UPDATE TO OXFORDSHIRE COUNTY COUNCIL'S RESPONSE TO CONSULTATION ON THE FOLLOWING DEVELOPMENT PROPOSAL

Application No: 17/02534/OUT-3

Proposal: OUTLINE - The construction of a business park of up to 60,000 sq.m (GEA) of flexible Class B1(a) office / Class B1(b) research & development floorspace; parking for up to 2,000 cars; and associated highways, infrastructure and earthworks

Location: Land North Of Bicester Avenue, Garden Centre, Oxford Road, Bicester.

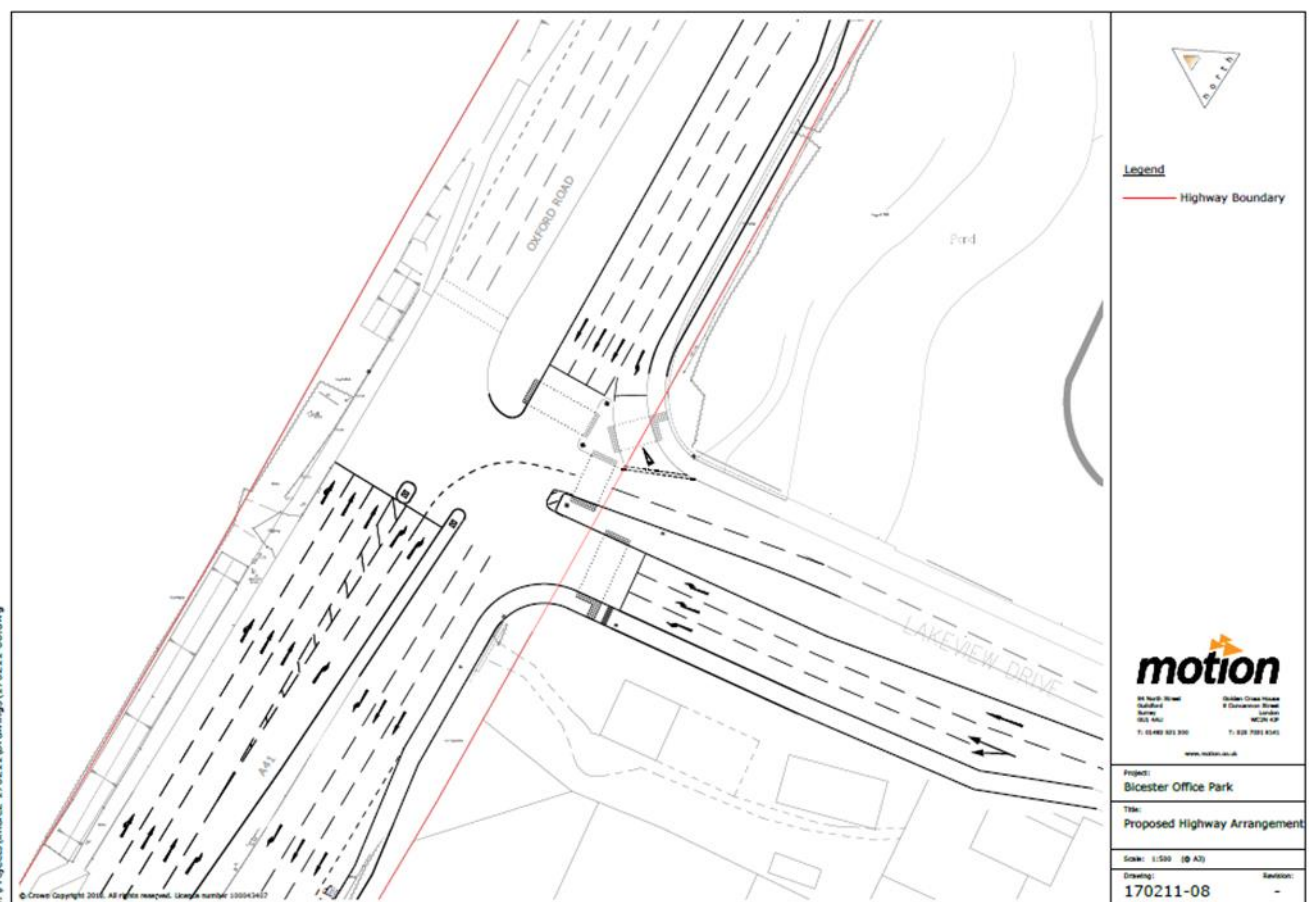
- Paragraph 8.9 states that third party advice has been sought on the appropriate threshold Degree of Saturation above which signalised junctions stop being considered to operate within capacity. It is the County Council's firm belief that in the transport industry it is widely accepted that where the Degree of Saturation (DoS) of a link in a LinSig model is shown to operate in excess of 90% DoS, that link is operating over capacity. The following extract from the TfL document "Traffic modelling Guidelines" supports this comment:

It is useful to be aware of the relationship between traffic delay and DoS in order to best optimise junction performance during proposal development. The relationship illustrated within Figure 8 strengthens the considerations outlined in Part A, which highlight the role stable network performance can play in maintaining journey time reliability. Engineers should be mindful that delay begins to increase exponentially above approximately 85% DoS. At junctions operating close to zero Practical Reserve Capacity (PRC), corresponding to approximately 90% DoS, small reductions in capacity can result in a significant increase in delay. For this reason a DoS of 90% represents an upper limit of practical capacity for signalised junctions. Unsignalised junctions typically have a lower practical capacity limit, with DoS in the range 80-85%. Junction capacity relationships are important when designing schemes in order to ensure that new proposals perform capably within the existing network.

Notwithstanding this, the LinSig modelling results for queuing show that the mitigation scheme is not adequate in terms of the resultant queueing. In other words, OCC is not objecting on the basis of an obscure technicality, but on predicted queueing, as paragraph 8.10 goes on to explain.
